METROPOLITAN GOVERNMENT OF NASHVILLE AND DAVIDSON COUNTY

STAFF RECOMMENDATION
105 South 11th Street
May 21, 2014

Application: Demolition—principle building; New construction—infill
District: Lockeland Springs-East End Neighborhood Conservation Zoning Overlay
Council District: 06
Map and Parcel Number: 08309018100
Applicant: Remick Moore
Project Lead: Melissa Baldock, melissa.baldock@nashville.gov

<p>Description of Project: The application is to demolish a non-contributing commercial structure and to construct a new one-story commercial structure.</p> <p>Recommendation Summary: Staff recommends approval of the demolition and infill with the condition that staff approve a brick sample and the window and door selections prior to purchase and installation of these materials. With this condition, staff finds that the project meets Sections II.B. and IV.B. of the <i>Lockeland Springs-East End Neighborhood Conservation District: Handbook and Design Guidelines</i>.</p>	<p>Attachments A: Photographs B: Site Plan C: Elevations</p>
---	--

1 WEST ELEVATION
1/8" = 1'

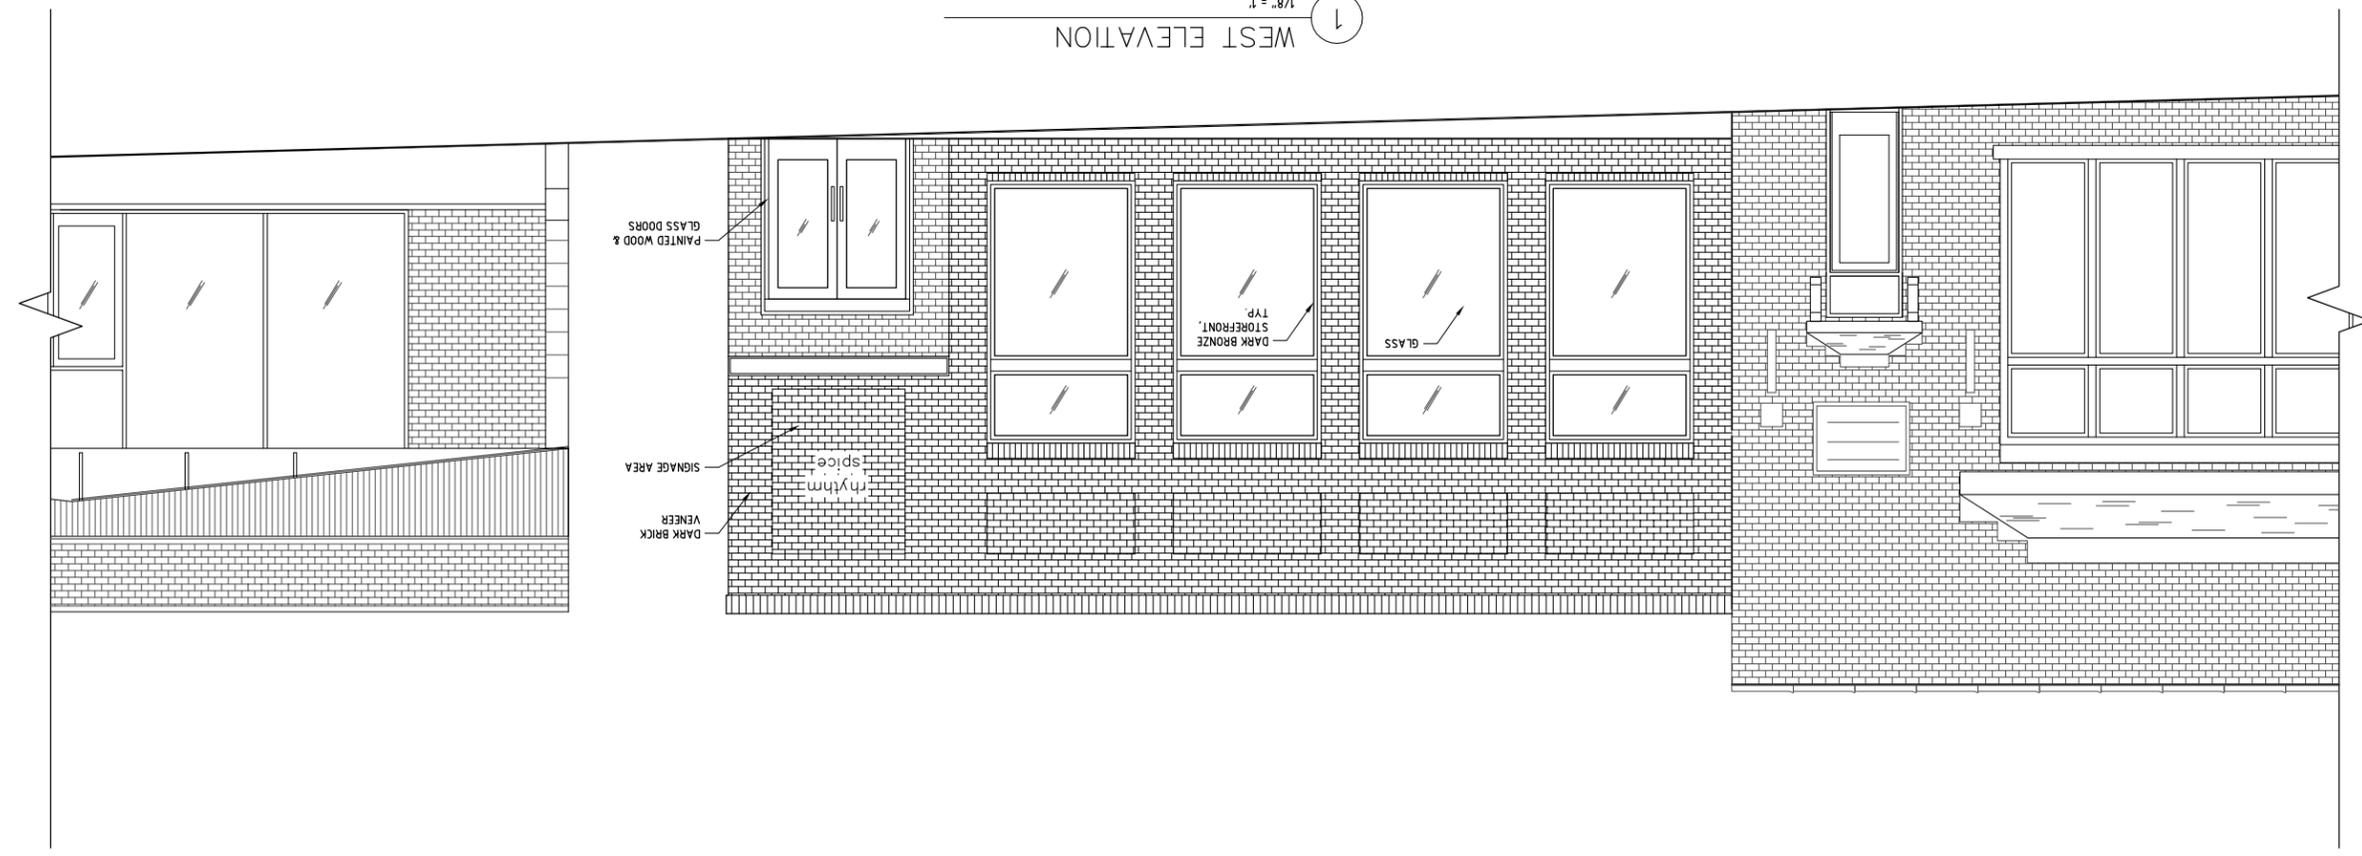
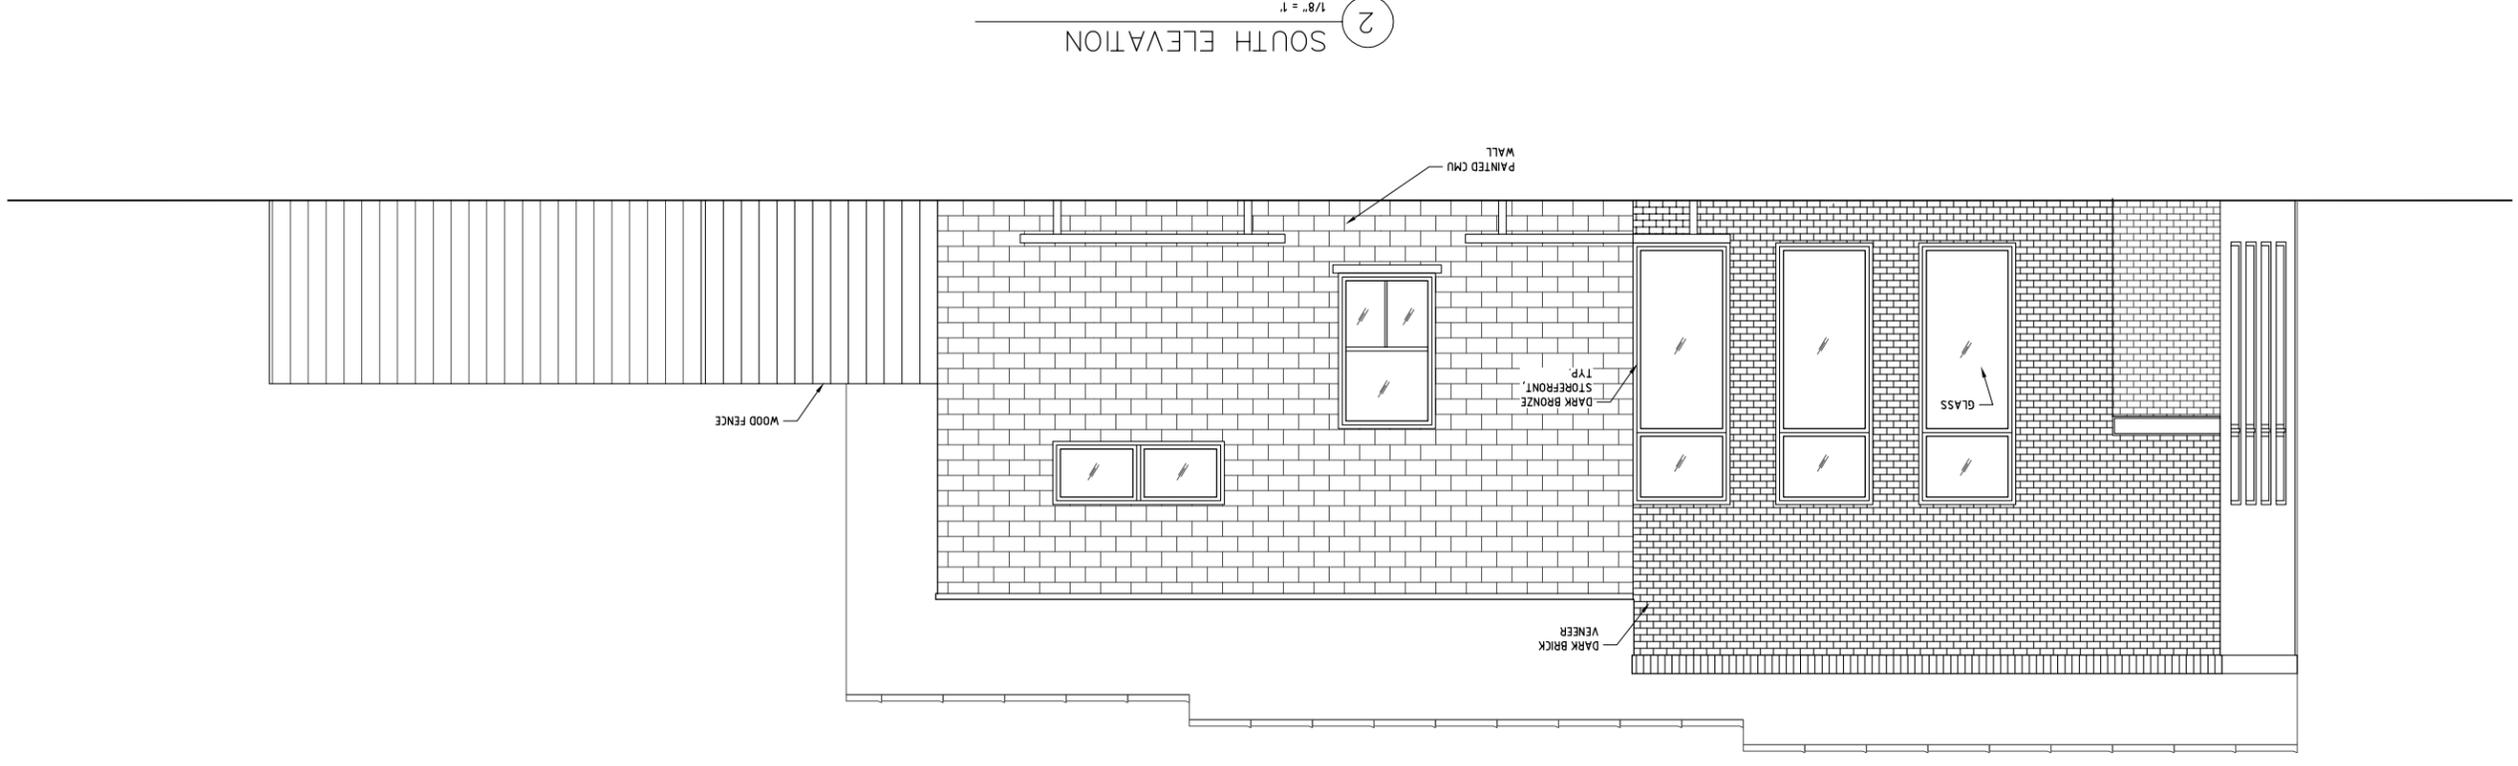
Materials: The front façade of the structure will be clad in brick, and staff asks to review a brick sample prior to purchase and installation of the material. The storefront windows will be aluminum storefront windows in a dark bronze color, and the primary doors will be glass and painted wood. Staff asks to review the final window and door selections. On the side façade, the brick will wrap the corner for approximately twenty-five feet (25'), after which the side façade will be painted concrete block. The rear façade will also be painted concrete block. Staff finds this to be appropriate because these two façades will be at most minimally visible from the street. A fence in the rear will be wood. The material of the roof will not be visible because the roof is flat. With the staff's final approval of a brick sample and the windows and doors, staff finds that the project's materials meet section II.B.4. of the design guidelines.

Proportion and Rhythm of Openings: The front façade will have four large storefront windows and a wood and glass entryway, which is appropriate. The south side elevation, which will be partially visible, will also have large window openings typical of a commercial structure. Staff finds that the project's proportion and rhythm of openings meet Section II.B.7. of the design guidelines.

Recommendation Summary: Staff recommends approval of the demolition and infill with the condition that staff approve a brick sample and the window and door selections prior to purchase and installation of these materials. With this condition, staff finds that the project meets Sections II.B. and IV.B. of the *Lockeland Springs-East End Neighborhood Conservation District: Handbook and Design Guidelines*.
